PROJECT NAME: NEXT DIMENSION CONSTRUCTION

PROJECT NUMBER: 2016110020

APPLICATION: MAJOR SITE PLAN #30535

SHEET DESIGNATION
C101
 SHEET
5 OF 17

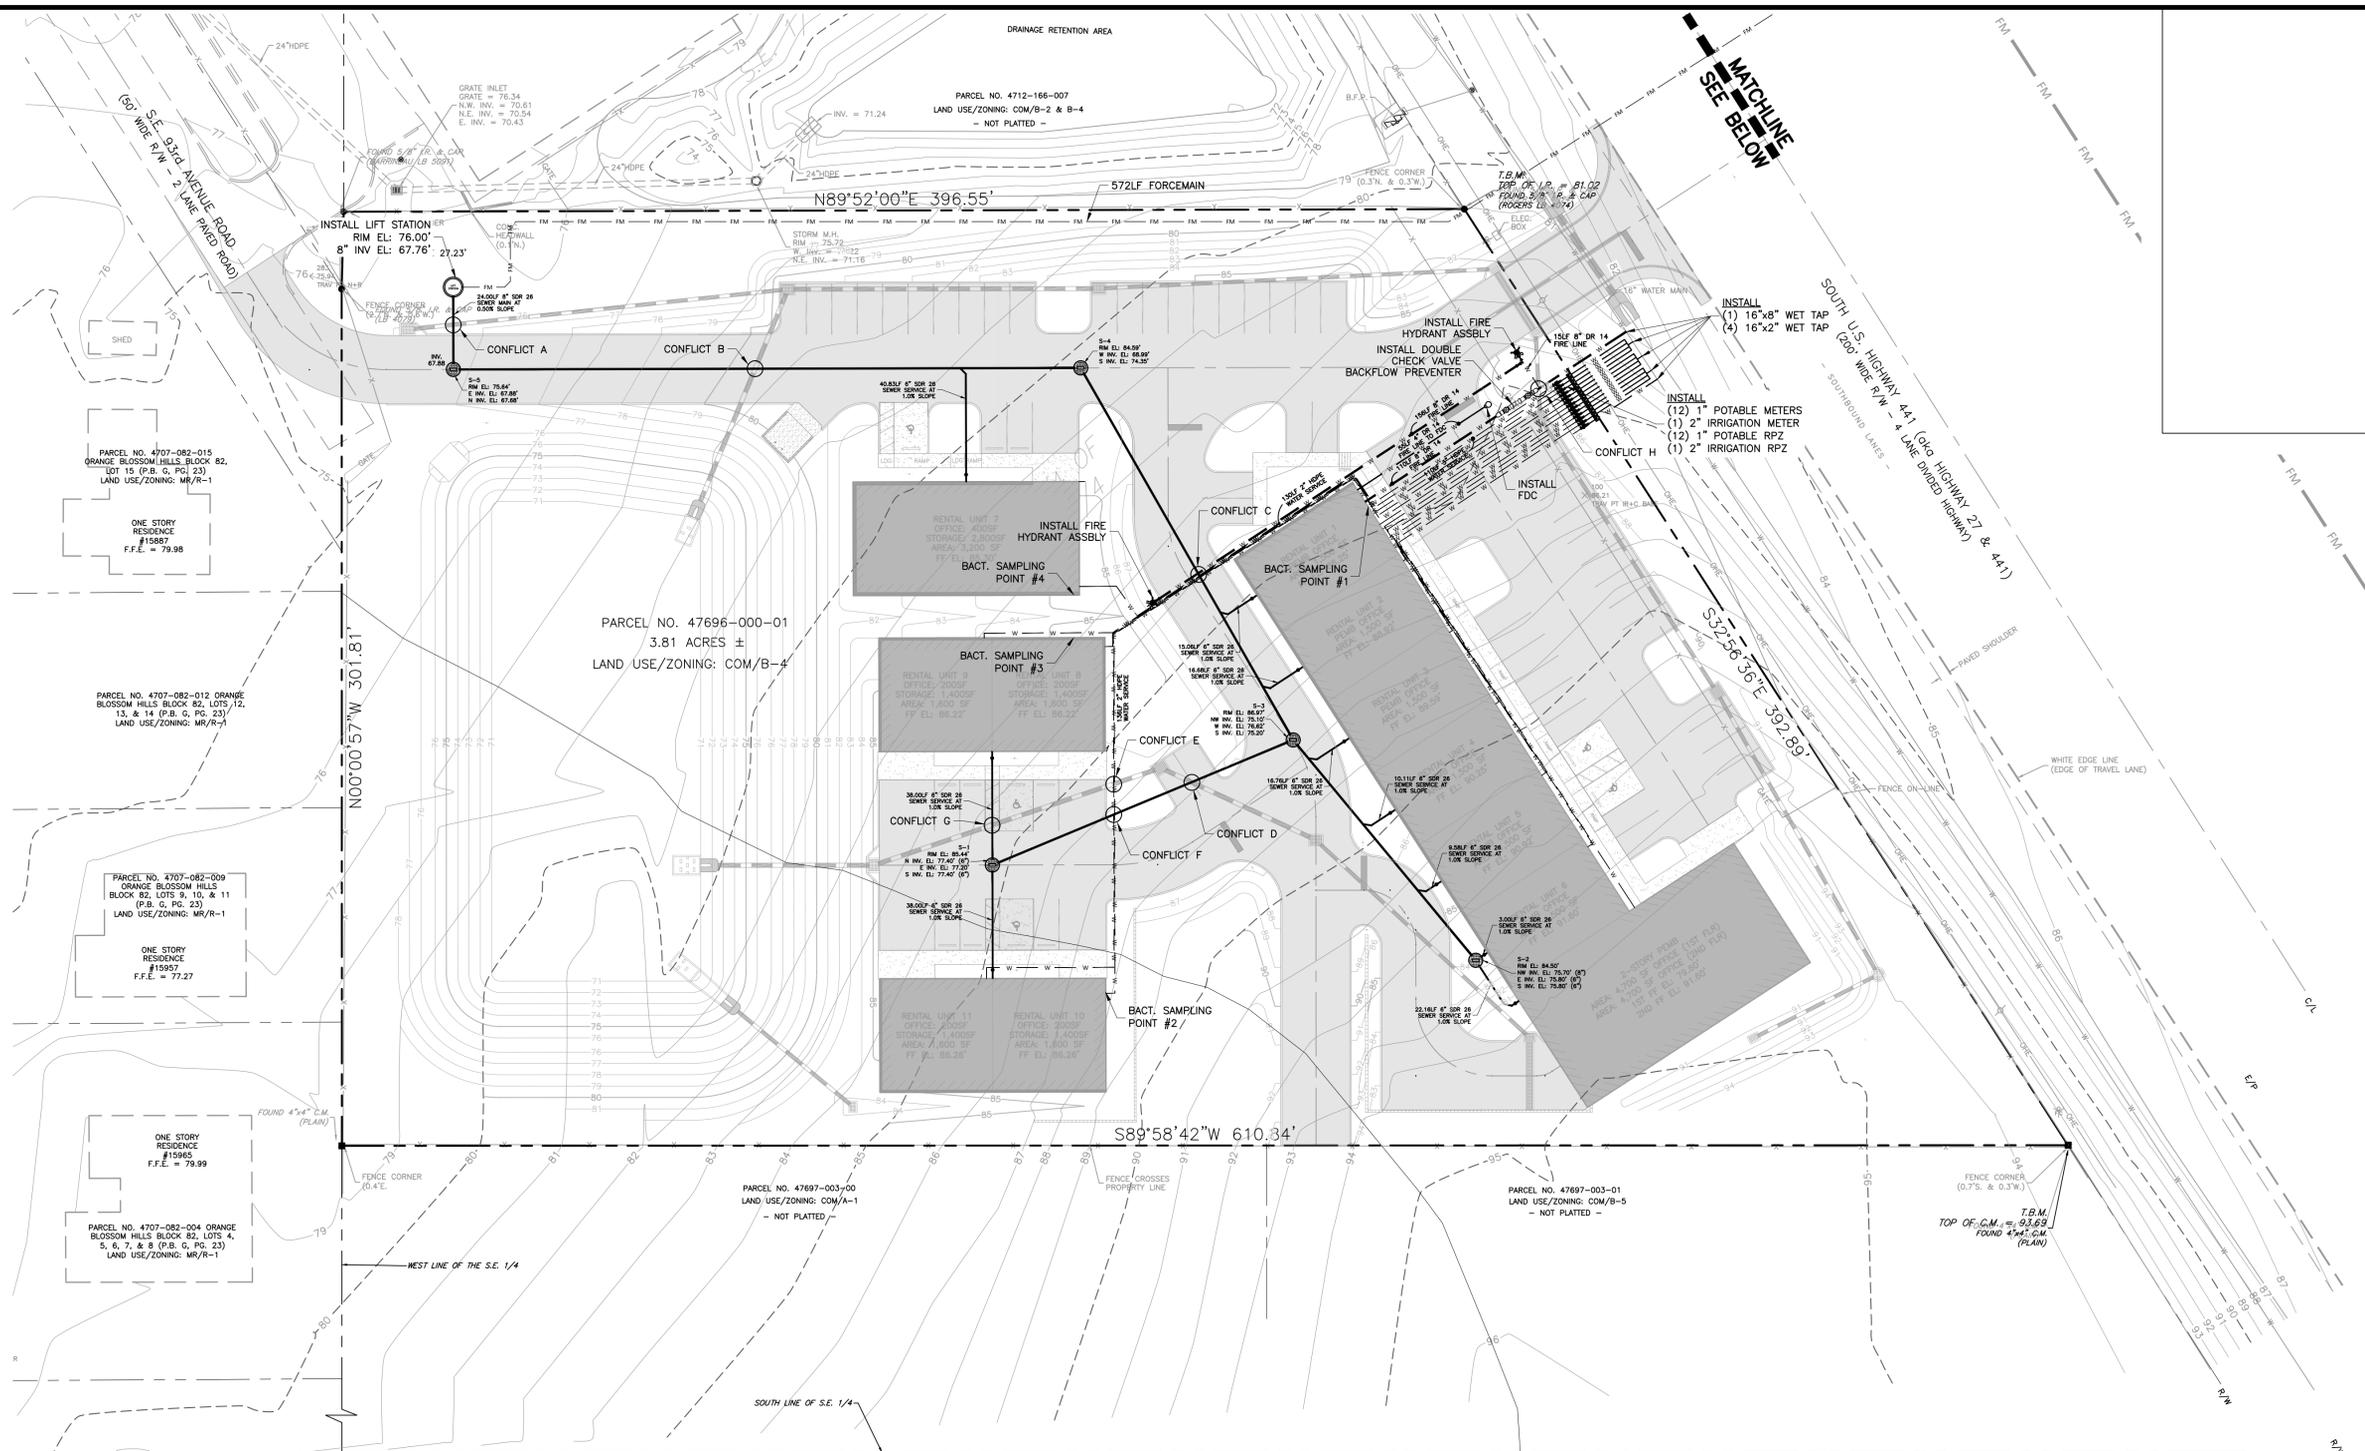
REMARKS: There are several pipes that are smaller than the 18" diameter minimum. Staff would support a waiver provided supporting calculations

SHEET DESIGNATION
C102
 SHEET
6 OF 17

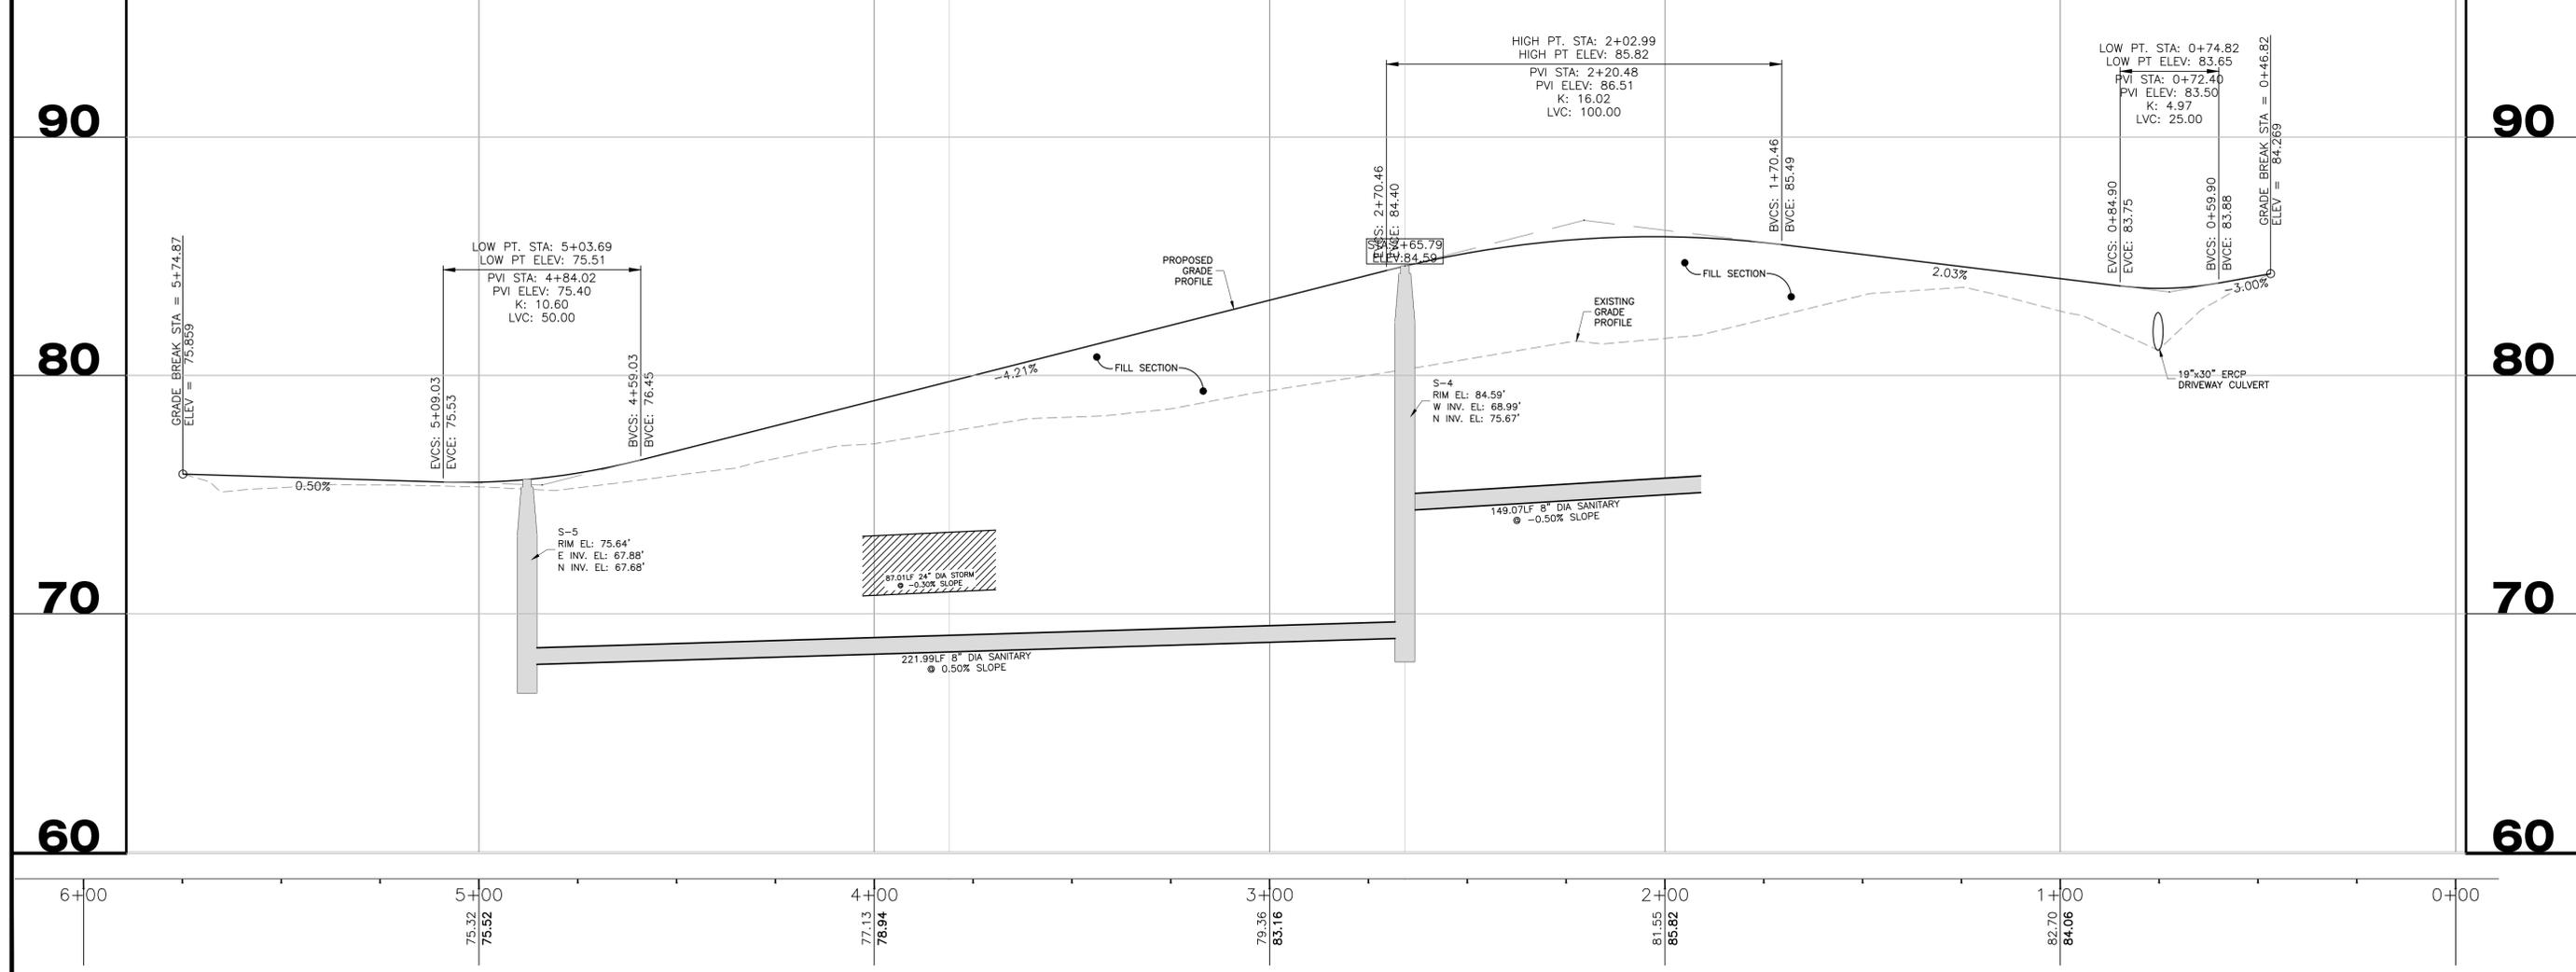
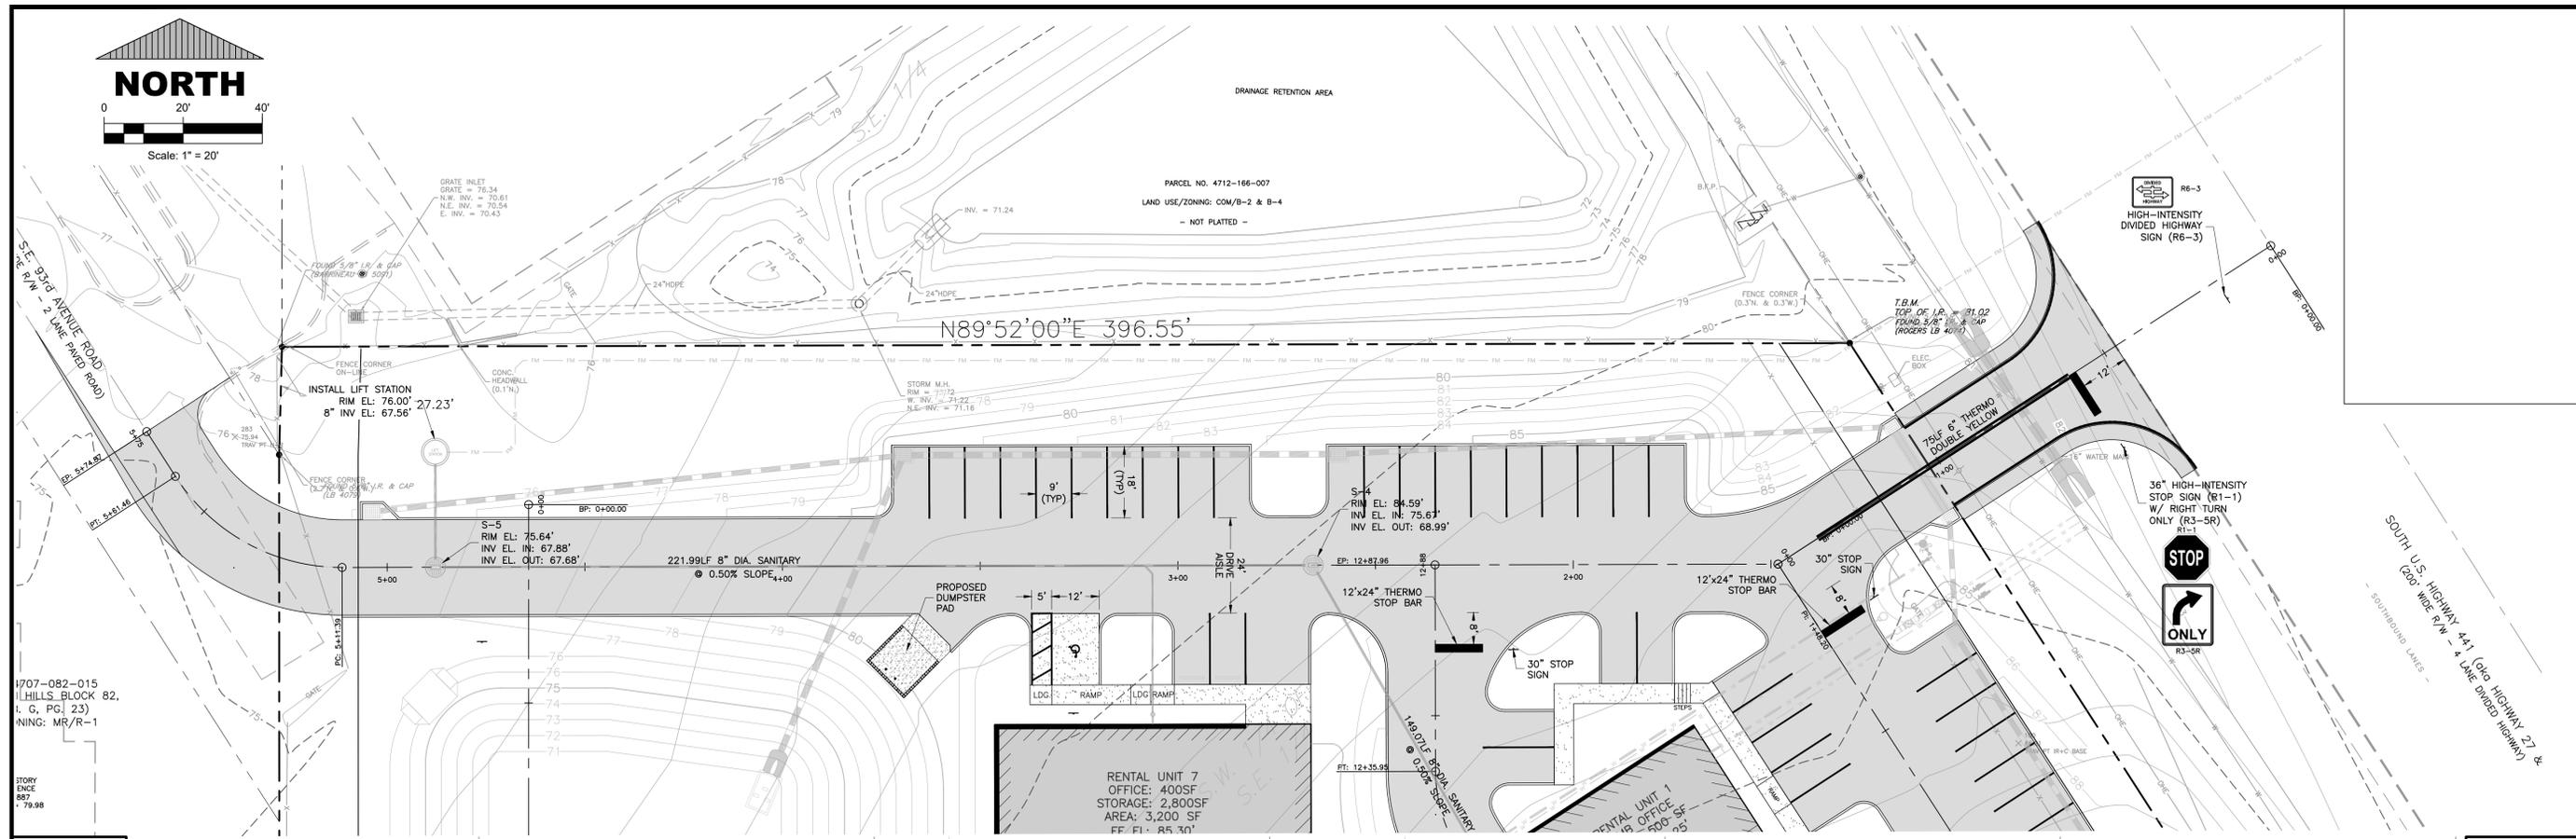
- 27 DEPARTMENT: UTIL - MARION COUNTY UTILITIES
REVIEW ITEM: 6.14.5.A(8) - Submittal Requirements - Connection to existing water system
STATUS OF REVIEW: NO
REMARKS: see changemarks on sheet C102 for connection notes

- 28 DEPARTMENT: UTIL - MARION COUNTY UTILITIES
REVIEW ITEM: 6.14.5.A(8) - Submittal Requirements - Connection to existing sanitary system
STATUS OF REVIEW: NO
REMARKS: see changemarks on sheet C102 for connection notes

- 30 DEPARTMENT: UTIL - MARION COUNTY UTILITIES
REVIEW ITEM: 6.14.7 - Construction Inspection - PLAN NOTE:
STATUS OF REVIEW: NO
REMARKS: Add to sheet C102 "MCU personnel are to inspect any work performed on or around existing MCU infrastructure. A pre-construction meeting is required to be held a minimum of 48 hours prior to start of any construction. If the pre-construction meeting is not completed, any work may be halted. To schedule, contact MCU's Construction Officer at 352-307-6163."

- 31 DEPARTMENT: UTIL - MARION COUNTY UTILITIES
REVIEW ITEM: 6.15.7 - Cross Connection Control and Backflow Prevention
STATUS OF REVIEW: NO
REMARKS: Backflow preventer noted needs to be changed to Double Detector Check Valve on Sheet C102

SHEET DESIGNATION
C600

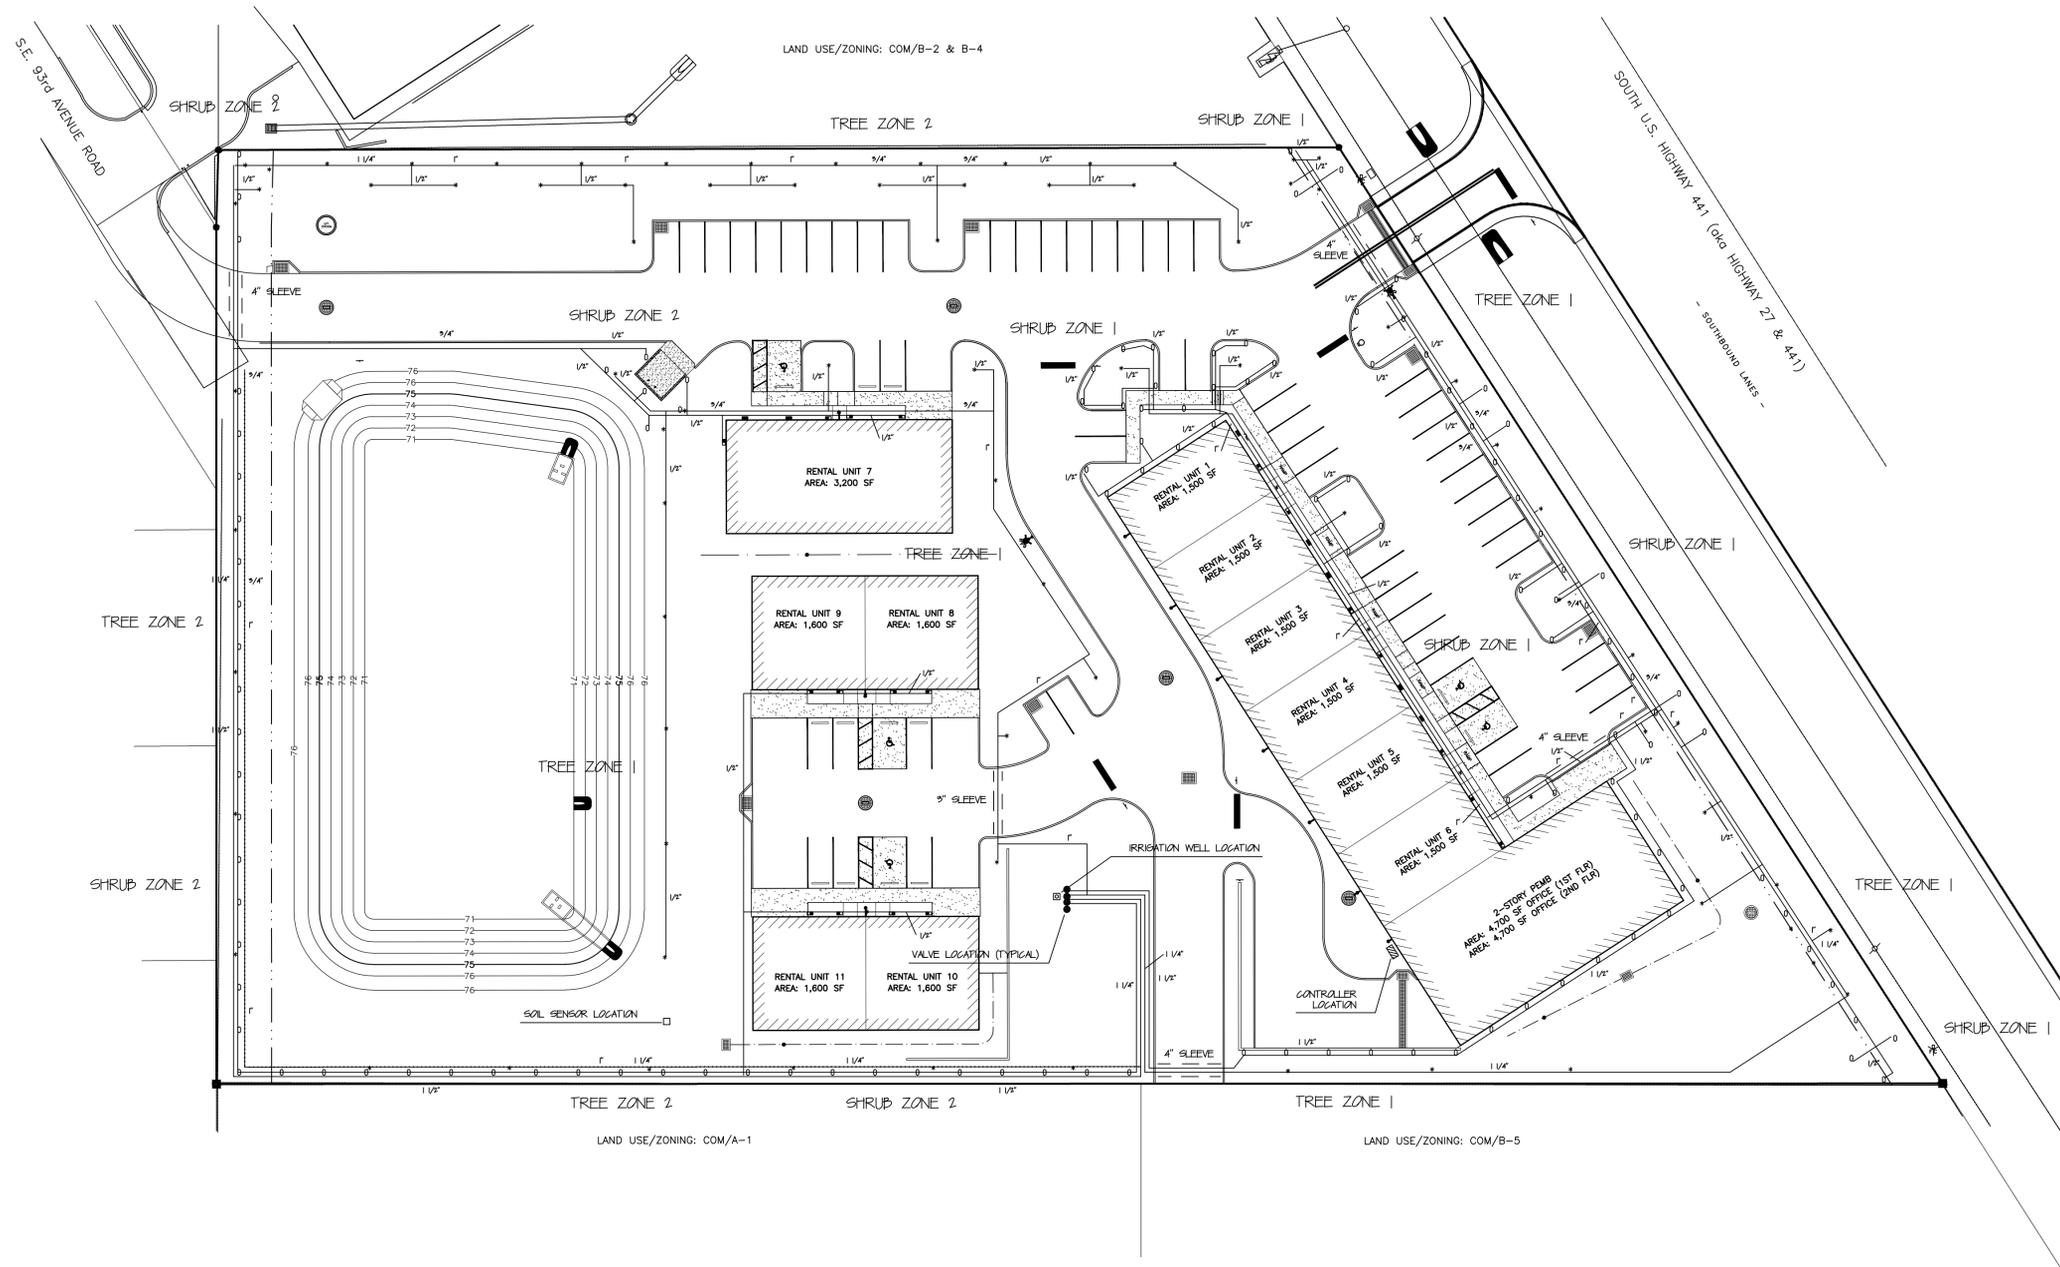
- 32 DEPARTMENT: UTIL - MARION COUNTY UTILITIES
REVIEW ITEM: 6.16.5.A & B - Private Wastewater Pump Stations
STATUS OF REVIEW: NO
REMARKS: Provide how Primary TDH determined (113) - sheet C600.
